# TECHNICAL BULLETIN

## Clutch Hydraulic Hose – Install Protective Sleeve – Service Action S 452

MODEL XJS (4.0L) Range 1994 MY

Service Action S452

ILLUSTRATION 1

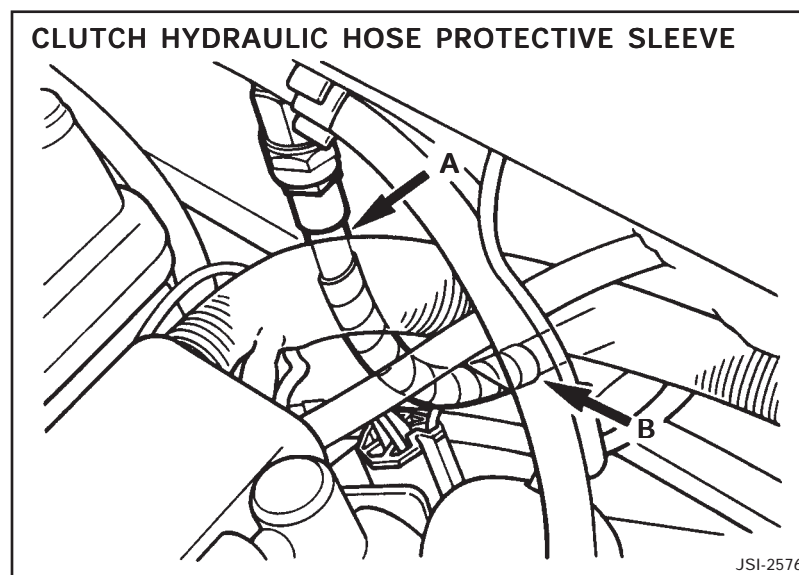
Some 4.0L XJS Range manual transmission vehicles within the above VIN range may experience interference between the clutch hose and the bulkhead heatshield. This condition may lead to abrasion of the clutch hydraulic hose.

1. Examine the clutch hydraulic hose between points A and B, Illustration 1. Check for signs of abrasion caused by contact with the bulkhead heat shield.
2. If **any** visible abrasion is found, replace the clutch hydraulic hose, bleed the clutch hydraulic system, and top up the fluid level as needed. If **no** abrasion is found, proceed to step 3.
3. On all vehicles, wrap the spiral protective sleeve (part number CCC 5388) around the existing or replacement clutch hydraulic hose from point A, the bulkhead attachment point, to point B where the rubber sleeve starts. Apply the wrapping so that no part of the flexible hose remains visible between points A and B, Illustration 1.

Inspect the hose at the next service opportunity or in the event of a customer complaint. On all vehicles, install a protective sleeve over the clutch hose as described below. Replace the clutch hose if abrasion has occurred.
